ECE/TRANS/WP.29/GRSG/2008/20
7 August 2008

REGULATION No. 107
(M₂ and M₃ vehicles)

Proposal for further amendments

Submitted by the expert from Spain */

" Figure 7

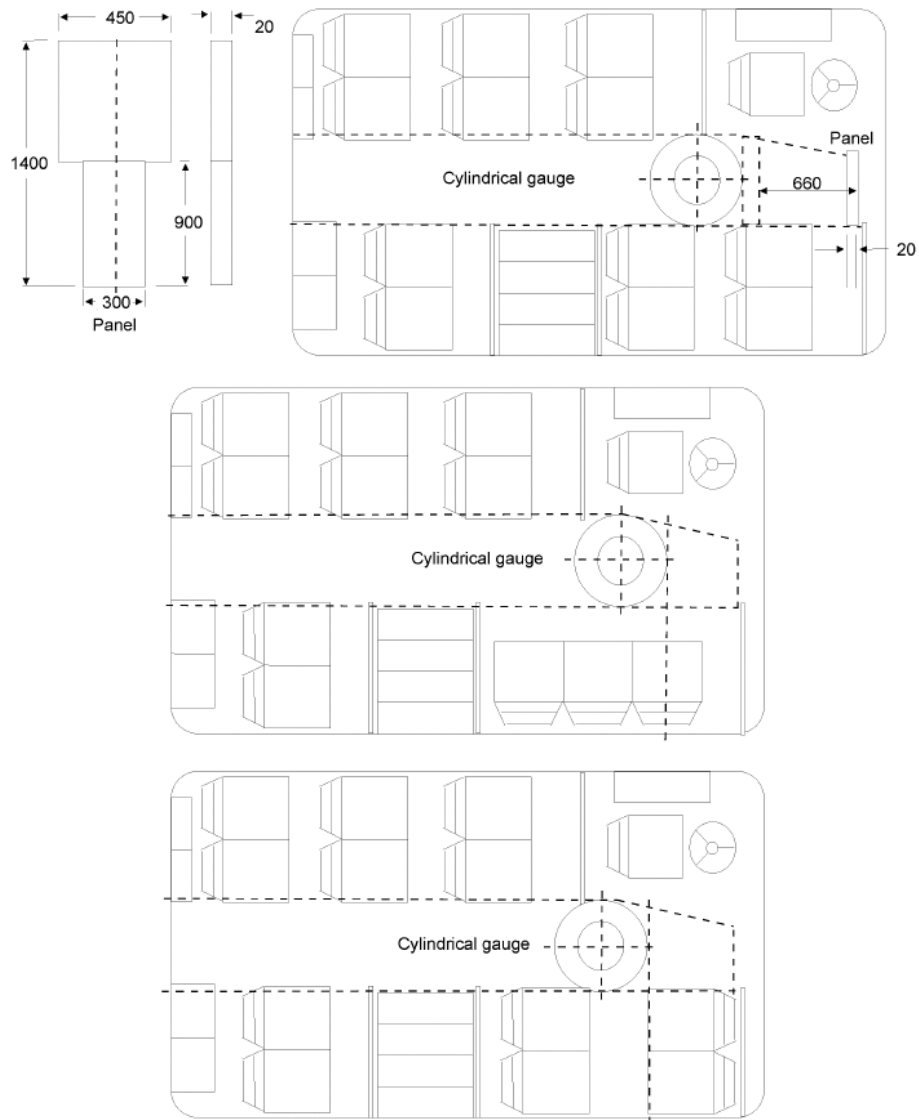
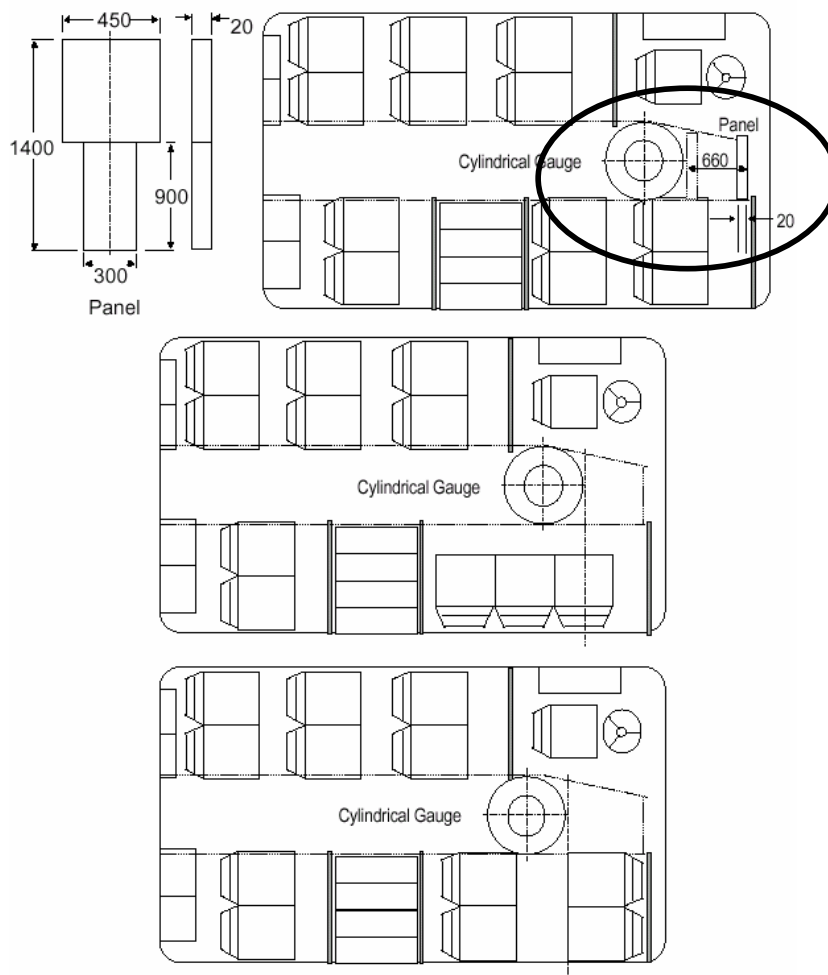
Annex 4, Figure 7, amend to read:

The surrounded part of the Figure shows how the forward limitation on the gangway has changed in Regulation No. 107 compared to Directive 2001/85/EC.

Due to the fact that Directive 2001/85/EC is used nowadays for many manufacturers and also because, as far as known, there is no specific reason to increase the forward pass, the experts from Spain propose to keep for Regulation No. 107 the same figure as described in Directive 2001/85/EC.

The proposed Figure 7 has been taken from Directive 2001/85/EC. Nowadays, the existent Figure 7 in Regulation No. 107 is:
